From: Dana Swift
To: Webb Research, Pete Furze
Date: October 31, 2017
Subject: **Hypothesis: Hull corrosion as an AWOL failure mechanism for APEX.**

Figure 2: The magenta curve measures the float's buoyancy during the park-phase of each profile cycle. The blue shaded region corresponds to a gradual gain of buoyancy that is compensated by piston retraction. The red shaded region represents a sudden loss of buoyancy just prior to float failure.

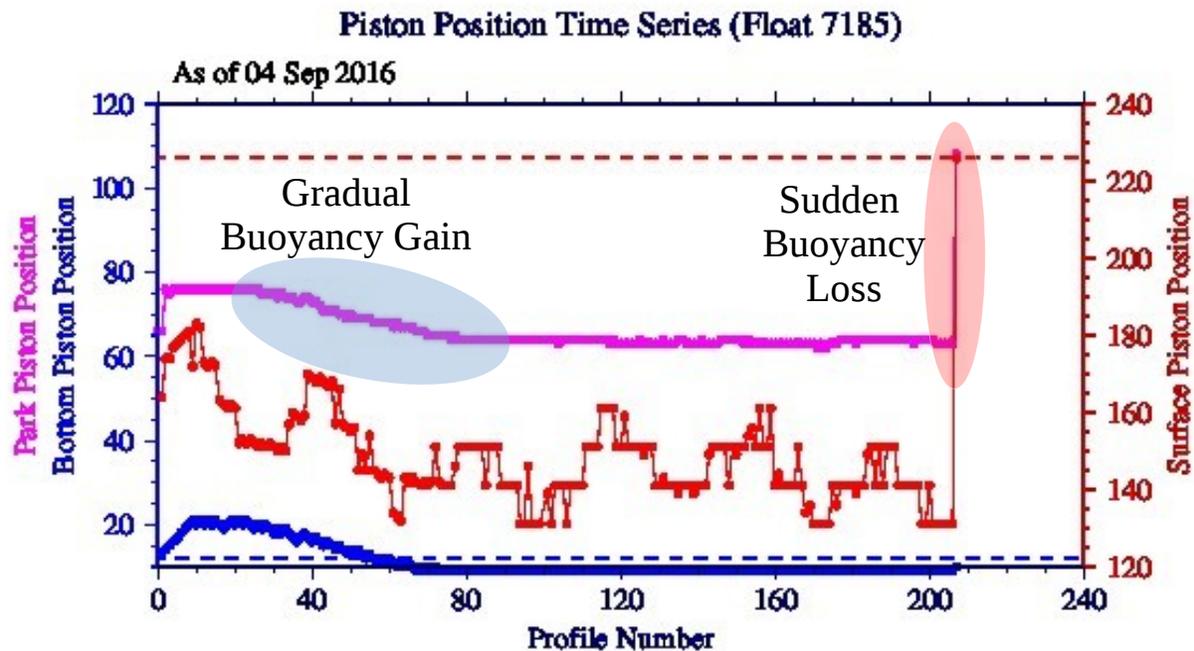
Ian's analysis revealed a widespread systematic set of symptoms that are the topic of this report. A canonical example is shown in Figure 2. The symptoms are a gradual gain of buoyancy relatively early in the float's life followed by long period of steady buoyancy and then frequently a sudden severe loss of buoyancy prior to premature failure of the float. The crucial hallmark of this syndrome is the sudden severe loss of buoyancy just prior to float failure.

The magenta curve represents a profile-series of the park piston position. Of course, during the park phase, the float actively ballasts itself to maintain the user-specified park pressure (ie., 1000dbars). Hence, the park piston position represents an accurate measure of the float's buoyancy. The shaded blue region in Figure 2 suggests that the float is reducing its buoyancy in order to compensate for a gradual increase in overall buoyancy of the float. Thereafter, the buoyancy remains steady until profile 207 when the float apparently suffers a sudden loss of buoyancy before failing entirely.

I have cast the description above in a way that is consistent with and suggestive of the same mechanism that caused PMEL's float 3020 to fail. My hypothesis is that the gradual gain of buoyancy is caused by the corrosive loss of anode mass and eventual loss of aluminum mass that starts out distributed over the

unpainted anodized surfaces of the upper and lower end-caps. Over time, the corrosion bores through the protective anodizing and thereafter the corrosion becomes more focused on a relatively smaller area of exposed raw aluminum. Eventually, a leak-path develops that causes the sudden loss of buoyancy. After a leak develops, most floats flood and sink without ever reaching the surface again. However, some floats manage to profile once or twice after a leak first develops. These floats exhibit the crucial hallmark symptom that so strongly supports the hypothesis.

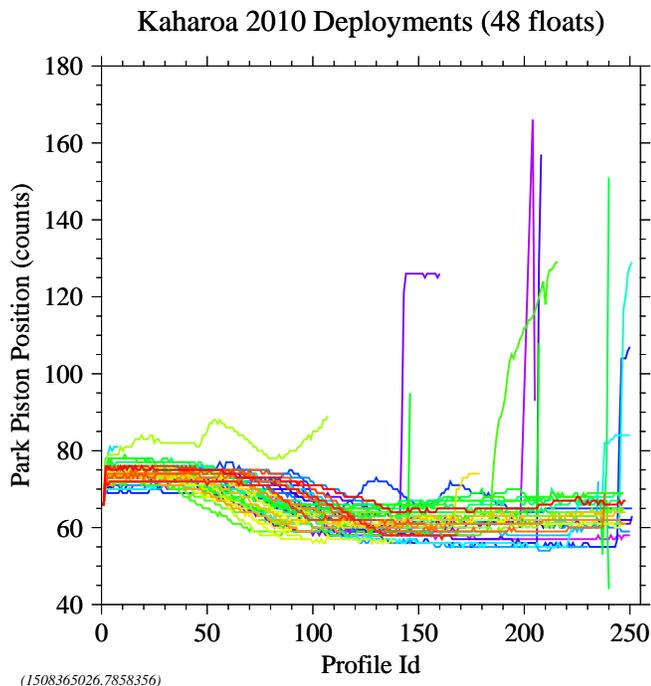
Other explanations for the symptoms shown in Figure 2 can be conjured that do not involve the gain or loss of buoyancy. However, Figure 3 demonstrates that this same cluster of symptoms are widespread and systematic. Forty-five out of the total forty-eight floats in the ensemble that I analyzed exhibit these symptoms. The systematic character of these symptoms renders any alternate hypotheses that I can think of to be not viable.

Of these forty-five floats, twenty-six floats failed prematurely leaving nineteen that still remain functional after more than seven years of operation. Ten of these floats that failed exhibited the sudden buoyancy loss just prior to failure. It is these ten floats that lend credibility to the supposition that all twenty-six floats failed due to corrosion-induced flooding.

Figure 5: PMEL Apex (WrcId) 2332 was deployed, recovered, refurbished, and redeployed. No wet parts were replaced during the refurbishment except for the anode. Symptoms of the syndrome are absent in the first deployment but present in the second.

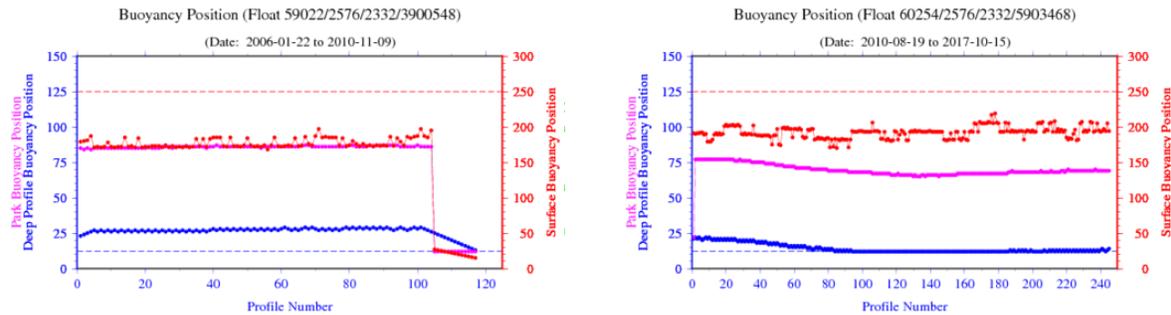
The left plot of Figure 5 shows the profile-series for the first deployment. Note that the park piston position remains steady throughout the mission until profile 104 when the float drifted into shallow water. The symptoms of the syndrome are completely absent during this deployment.

The right plot of Figure 5 shows the profile-series for the second deployment. The park piston position remains steady at 77 counts for the first 28 profiles after which it gradually decreases to 65 counts at profile 130. This 12-count change is very consistent with the gradual increase in buoyancy of UW floats as shown in Figure 3.

For these two missions executed by the same float, the parts in direct contact with seawater differed only due to replacement of the anode. This constitutes pretty convincing circumstantial evidence that the anode was the root cause of the gradual increase in buoyancy that is characteristic of this syndrome. It strongly suggests that the change in anode material happened sometime between 2006 and 2010.

If confirmed, then correcting the problem might be as straightforward as reverting to the use of a suitable aluminum anode. To further protect the vulnerable parts of the end-caps, we could also consider painting a band near the hull o-ring groove to seal it from contact with seawater.
